TRAILS AT ASPEN RIDGE - STOCKPILE

GRADING & EROSION CONTROL PLANS

EPC'S EDARP FILE NUMBER: CDR2312

V2_GEC Plan.pdf Markup Summary

GRADING AND EROSION CONTROL PLAN

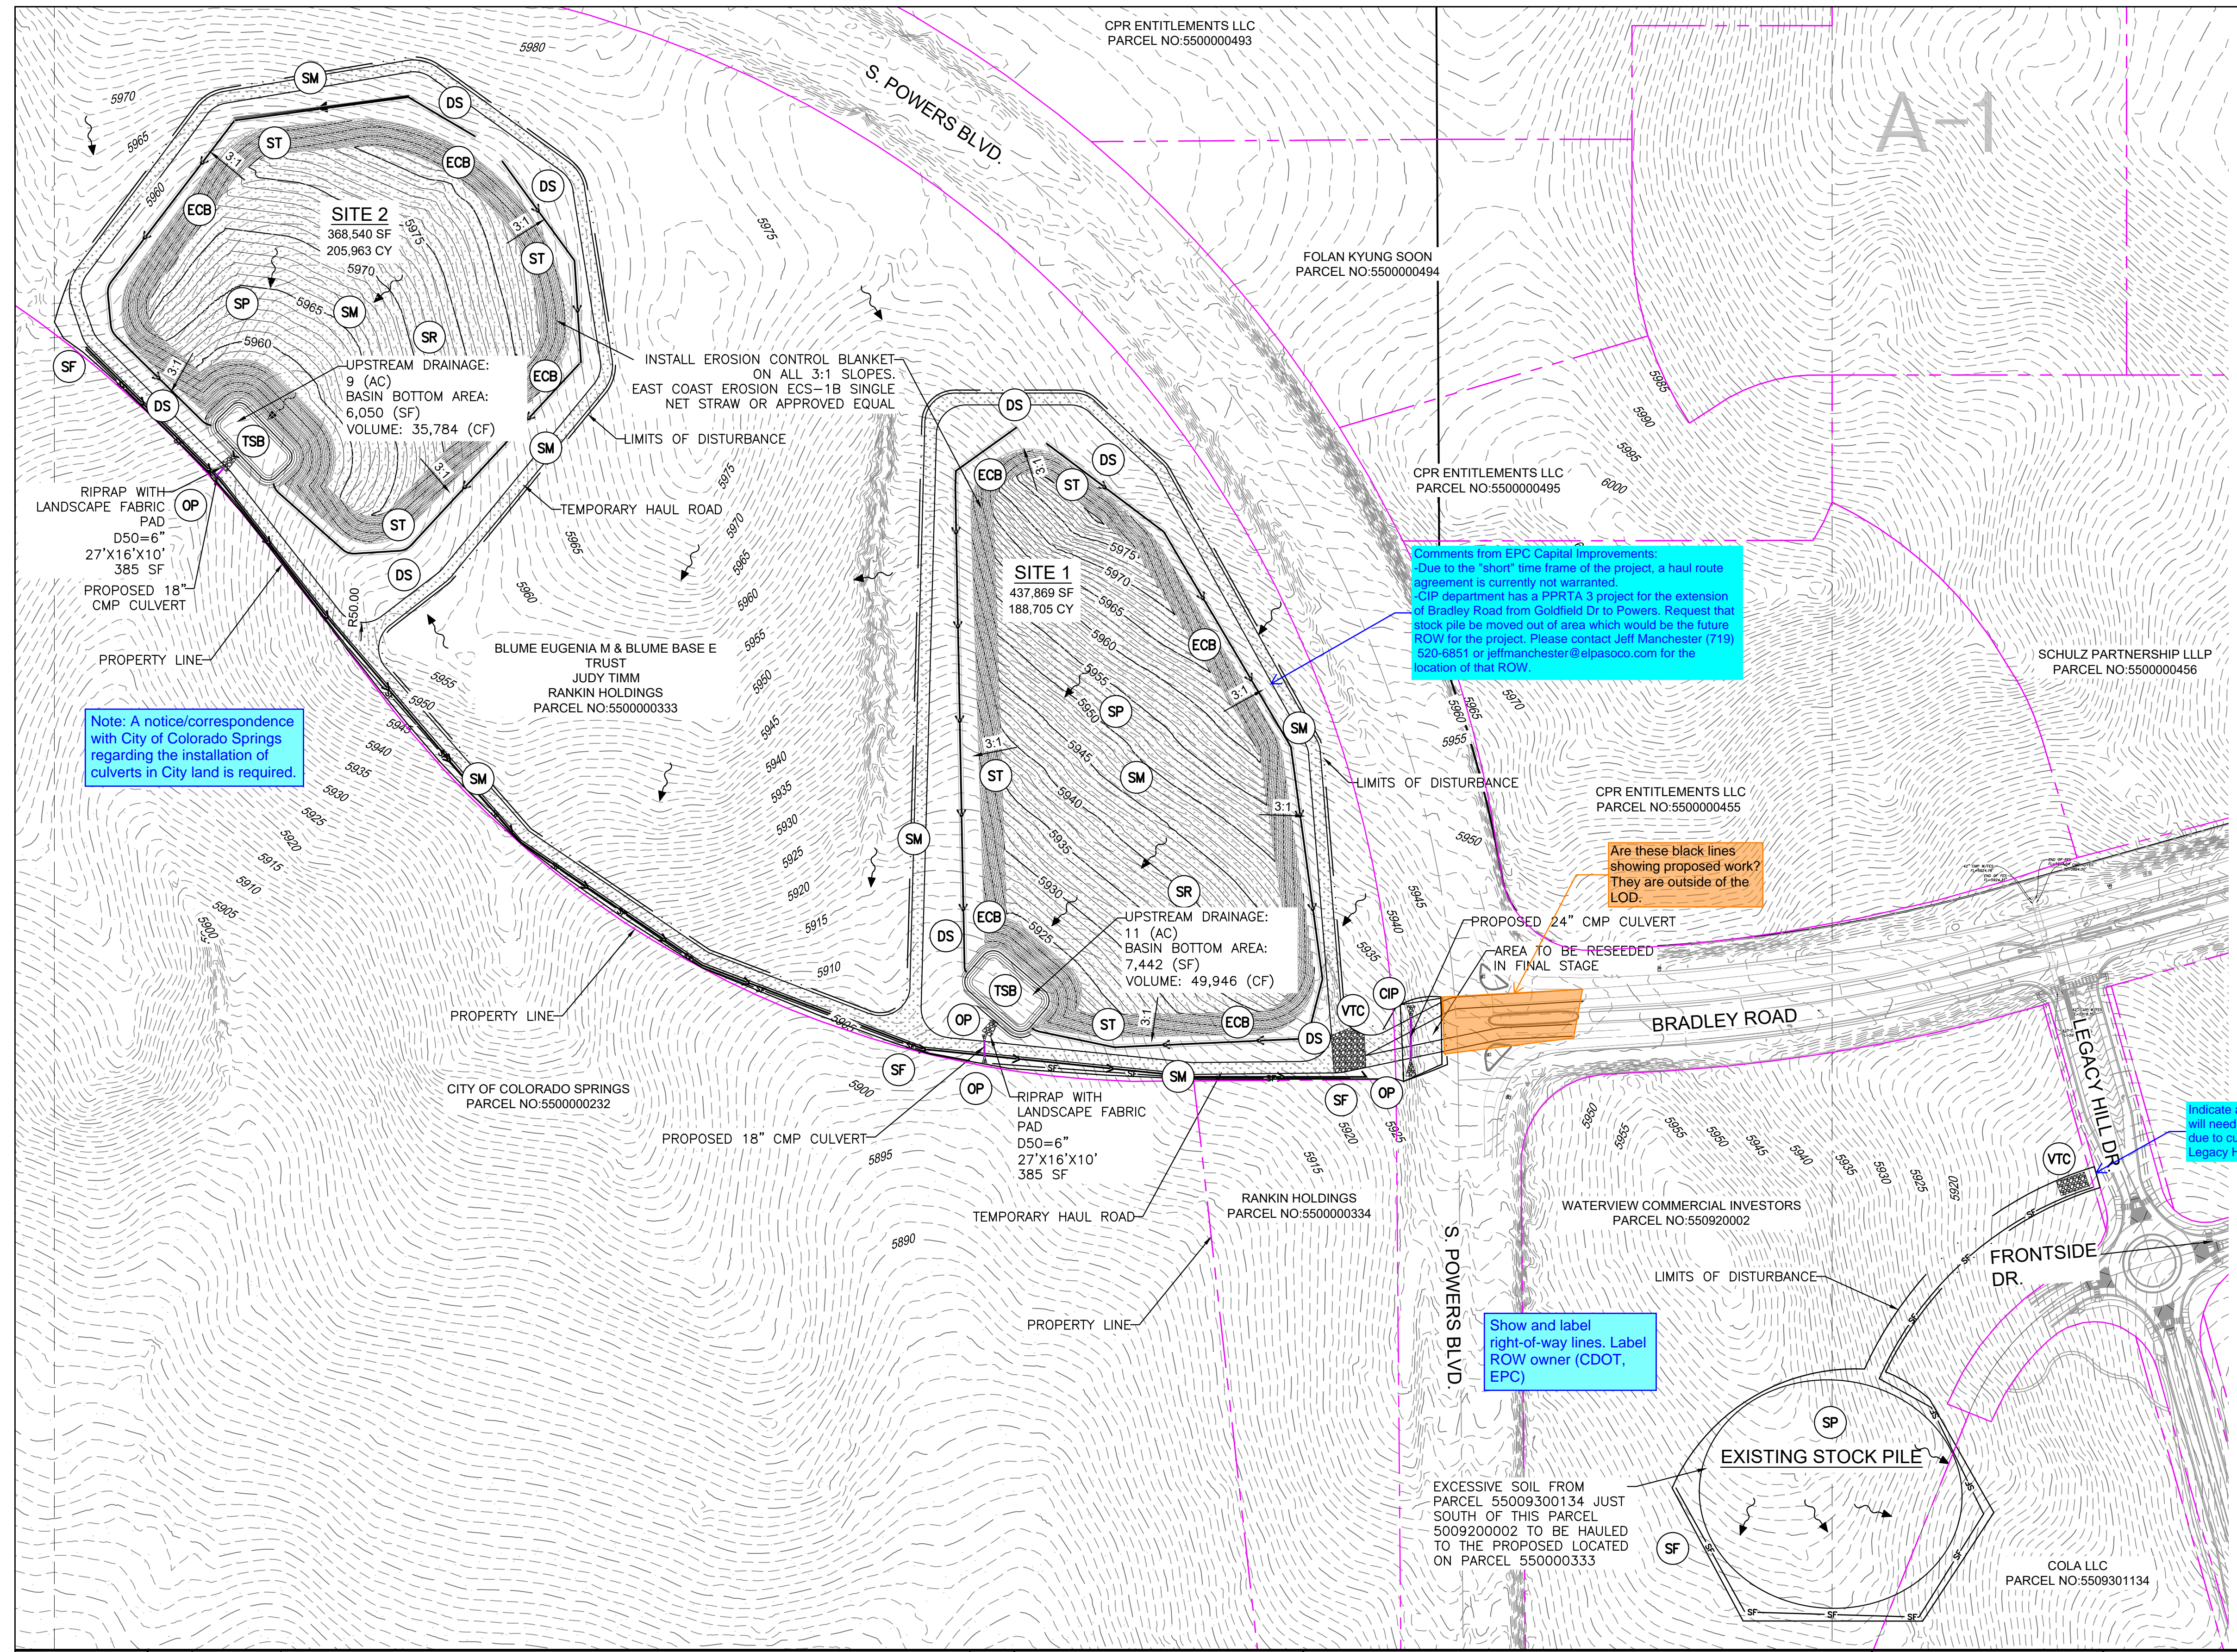
Please also add TSB to the list of Final BMPs below. We think it'd be best to just leave them in place and seed them when the stockpiles are complete.

Swale needs to be installed in interim phase (soon after installation of TSB and hauling begins) in order to convey runoff from all vegetated soils to TSBs.

It's unclear what the intended difference is between these two notes is, especially since a Landscape Plan was not submitted. Revise to clarify.

Likely just need one note for seeding req's that summarizes or references DCMv2 - Section 3.2 - General Principles - Basic Grading, Erosion and Stormwater Quality Requirements and General Prohibitions #16:

Note: A notice/correspondence with City of Colorado Springs regarding the installation of culverts in City land is required.

Show and label right-of-way lines. Label ROW owner (CDOT, EPC)

TRAILS AT ASPEN RIDGE - STOCKPILE					
CONSTRUCTION DRAWINGS GRADING AND EROSION CONTROL PLANS					
HAUL ROUTE PLAN					
DESIGNED BY:	NMS	SCALE	DATE ISSUED:	MAY 2023	DRAWING No.
DRAWN BY:	TRS	HORIZ	N/A	4 OF 8	HR01
CHECKED BY:	NMS	VERT.	N/A	SHEET

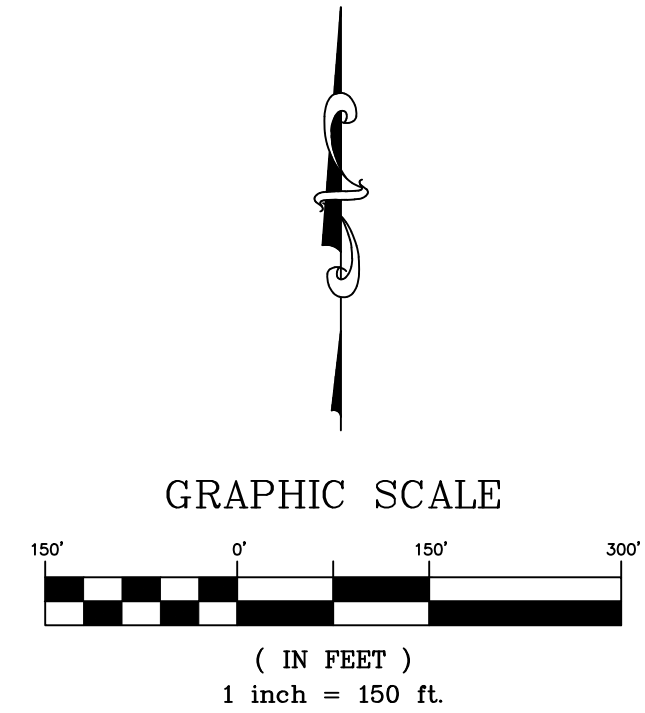
Label roads

Show and label right-of-way lines. Label ROW owner (CDOT, EPC)

VEHICLE TRACKING CONTROL	
APPROVED:	
SHEET MANAGER:	
ISSUED:	10/7/19
REVISION:	8/19/2020
DRAWING NO.:	900-VTC

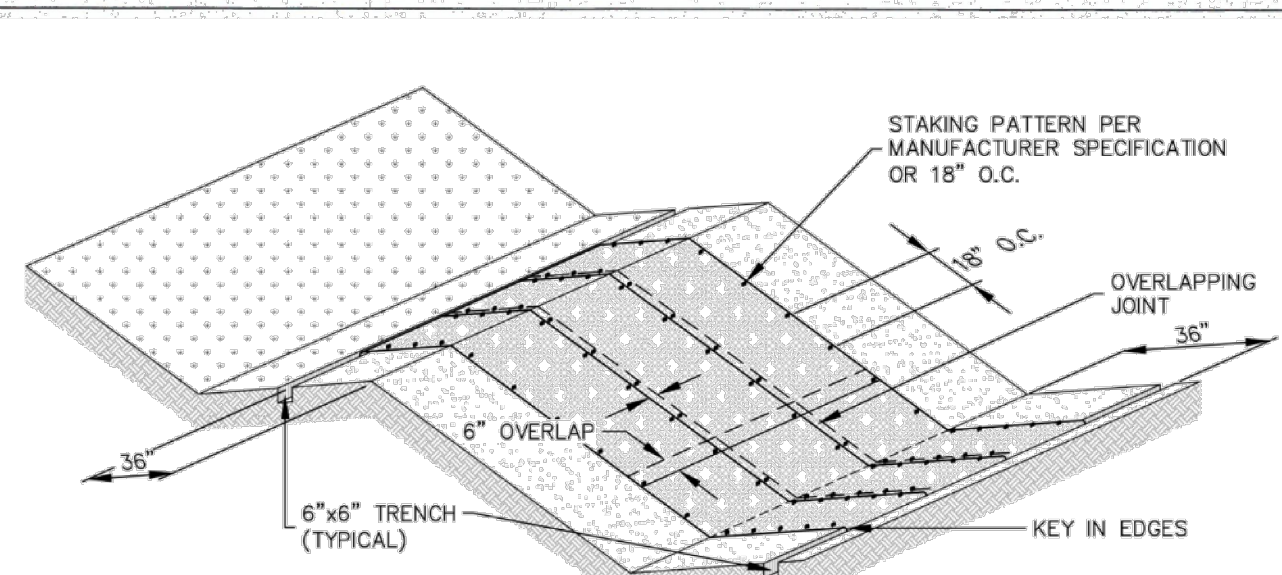
Replace with EPC approved VTC detail (VT-1 and VT-2 in DCMv2, Chap 3.3) or revise to be 75ft min length.
